**GENERAL PLAN AND ELEVATION
C.H. 6 (270TH STREET) OVER
HENDERSON CREEK
SEC. 18-00113-00-BR
MERCER COUNTY
STATION 5+85.00
STRUCTURE NO. 066-3024**

**MERCER COUNTY HIGHWAY DEPARTMENT
C.H. 6 (270TH ST.) OVER HENDERSON CREEK
STATION 5+85**

GENERAL PLAN AND LAYOUT

BEARING DETAILS
STRUCTURE NO. 066-3024
STRUCTURAL SHEET NO. 11 OF 21 SHEETS

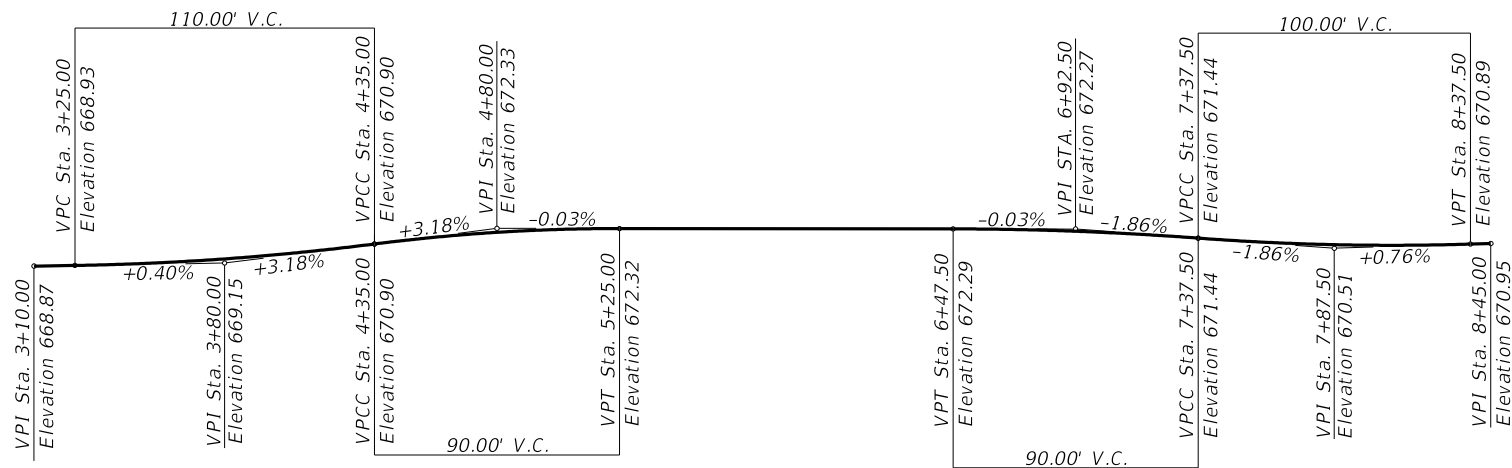
Fasteners shall be ASTM A325 Type 1, ~~mechanically~~ hot dip galvanized bolts, Bolts 7/8" Ø, holes 1 1/8" Ø, unless otherwise noted.

REVISION	DATE	BY	REMARKS	DESIGNED	ATK
1	12/14/23	ATK	HOT DIP GALVANIZED BOLTS	DRAWN	DAN
				REVIEWED	ATK
				APPROVED	MRL

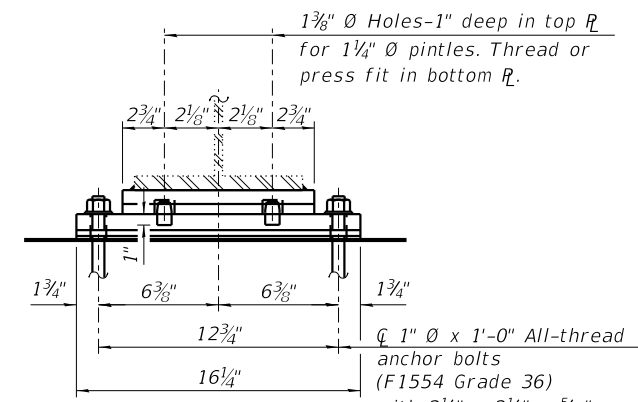
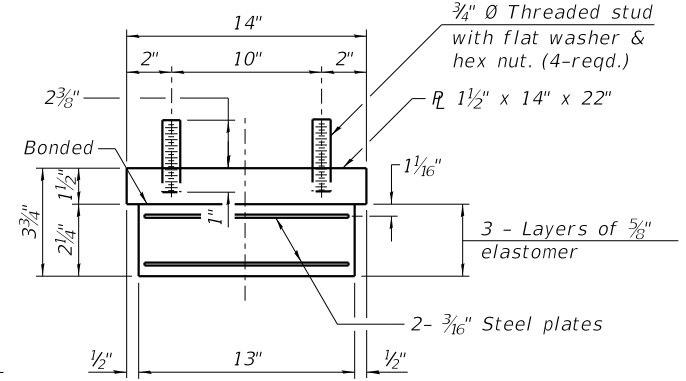
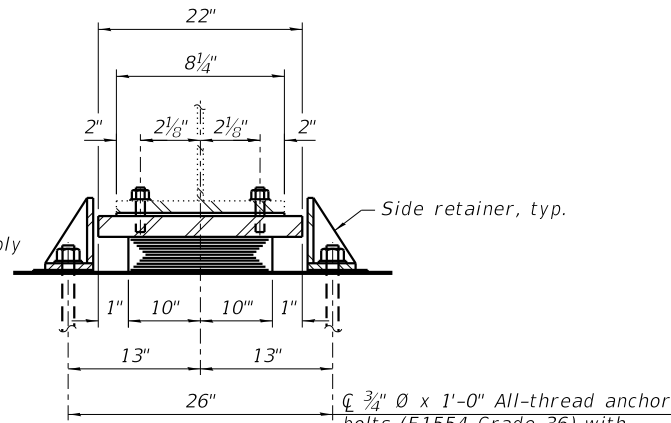
REVISION	DATE	BY	REMARKS	DESIGNED	ATK
1	12/14/23	ATK	REMOVED FIELD WELD	DRAWN	DAN
				REVIEWED	ATK
				APPROVED	MRL
